Woodbarn Farm, Broadford Bridge

Stage 1 Road Safety Audit

6 July 2012
Final Report
9X0727-04

Document title Woodbarn Farm, Broadford Bridge
Stage 1 Road Safety Audit
Document short title Woodbarn Farm: Stage 1 RSA
Status Final Report
Date 6 July 2012
Project name Woodbarn Farm, Broadford Bridge
Project number 9X0727-04
Client Barton Willmore
Reference 9X0727-04/RSA02/304032/Birm

LOCATION OF ROAD
SAFETY AUDIT PROBLEMS

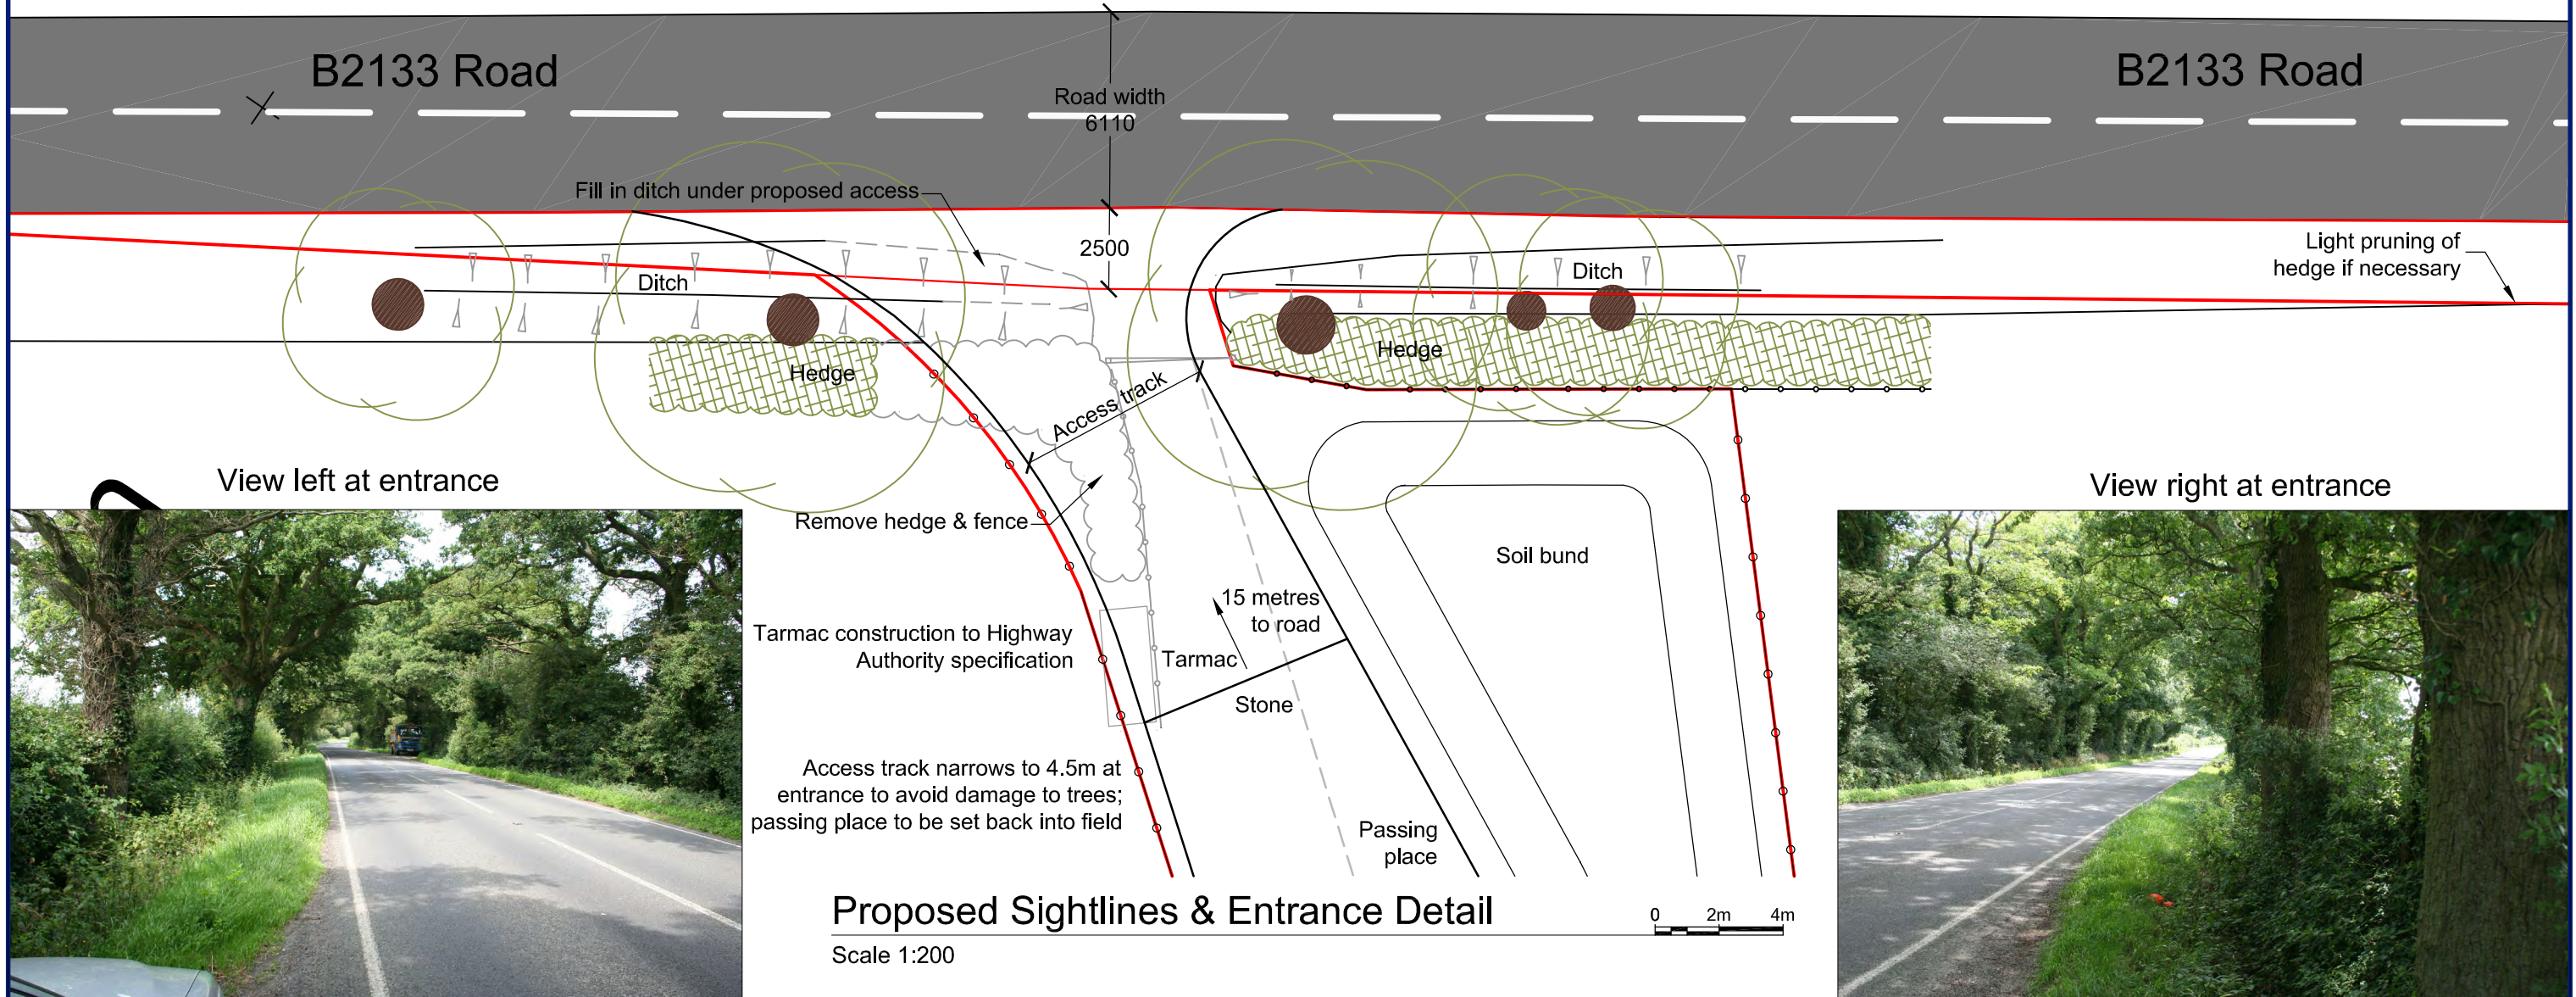
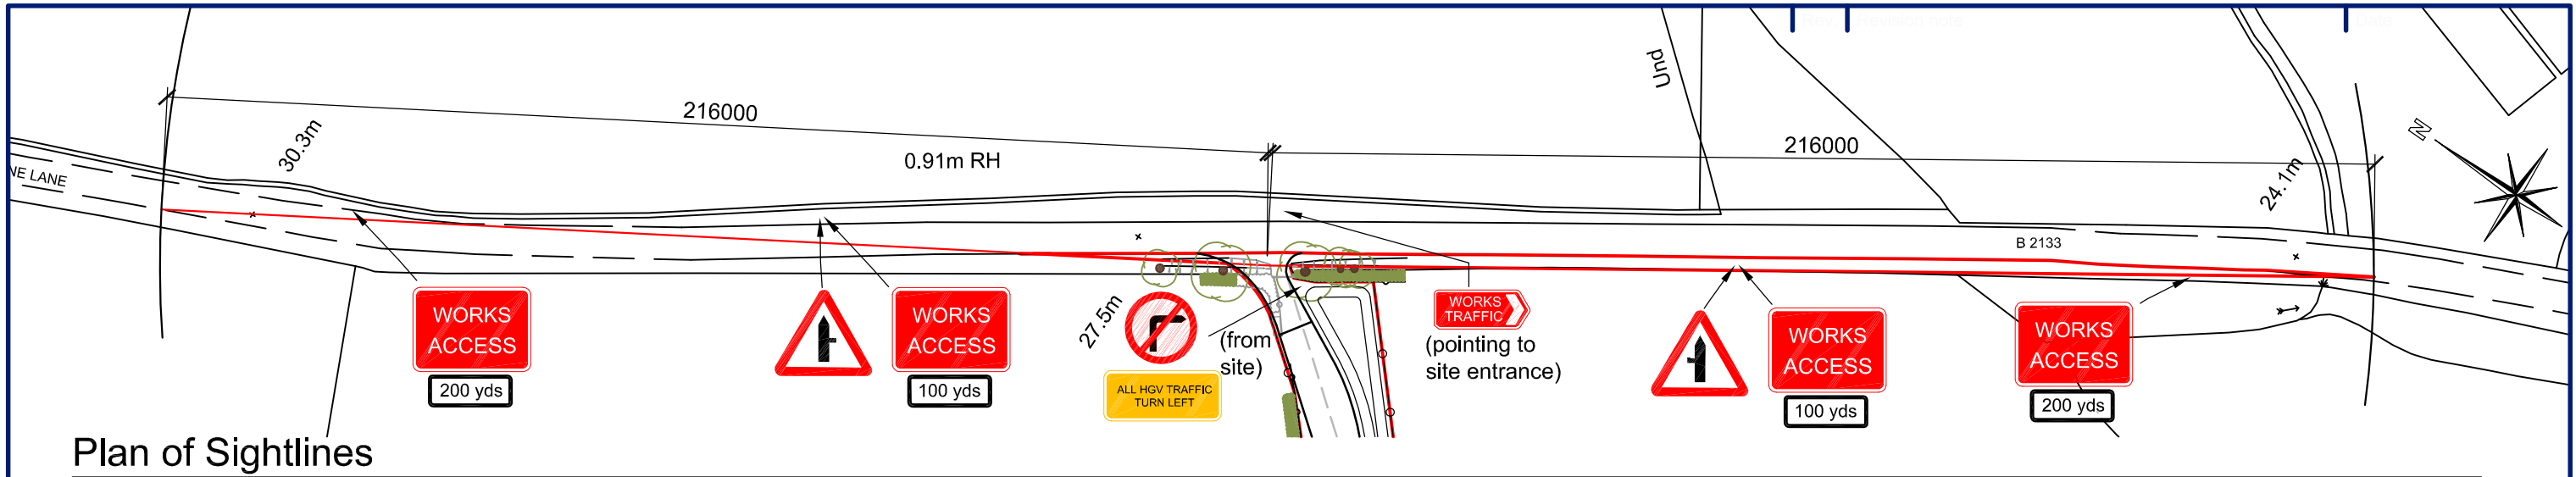
Location: Proposed site access, Adversane Lane

Description: Existing drainage ditch running along site boundary could flood where filled to accommodate access construction, leading to potential to create ponding / flooding on Adversane Lane.

Location: Proposed site access, Adversane Lane

Description: Large vehicles accessing / egressing the proposed development would create conflict with other road users if unable to safely access the site in a simple manoeuvre.

Location: Proposed site access, Adversane Lane

Description: Proposed arrangement shows existing drainage ditch with no earthworks tie-in from access channel to ditch level. Aside from structural reasons, a verge should be provided to accommodate vehicle overrun into the ditch.

Location: Proposed site access, lateral visibility to east.

Description: Visibility to right when egressing sight constrained by overgrowth of verge landscaping, which could result in conflict between vehicles exiting the site and those travelling westbound along Adversane Lane.

Location: Approaches to proposed site access from Adversane Lane

Description: Information and warnings conveyed by road signage to drivers at risk of being lost as a result of unclean signage on approaches to the proposed access, resultant from muddy, wet surface conditions observed during site visit.

Location: Approaches to proposed site access from Adversane Lane

Description: Sign mounting details not provided for Stage 1 Road Safety Audit. Signs mounted without sufficient clearance of vehicles travelling in both directions on the relatively narrow Adversane Lane are at risk of vehicle strikes.

Drainage measures should be provided where ditch is to be filled, ensuring ponding / flooding does not arise on Adversane Lane as a result of the proposed access construction.

Provide drawings showing swept path analysis for all vehicle types required to access / egress the proposed development, ensuring vehicle movements can be undertaken in a single manoeuvre to avoid unnecessary conflict with traffic travelling on Adversane Lane.

Provide appropriate minimum verge width and embankment to ditch level to ensure any vehicle overrun does not result in any vehicles overrunning the channel line tumbling into the ditch.

Ensure visibility splays meet required standards by trimming overgrown verge landscaping, ensuring a maintenance regime for verge trimming is in place for the lifespan of the development access.

Implement regular sign cleansing maintenance regime, ensuring signage gives clear warning of proposed construction access particularly during autumn / winter conditions and hours of darkness.

Ensure sign mounting details are provided for Stage 2 Road Safety Audit, giving consideration to road width and visibility with context to landscaping.
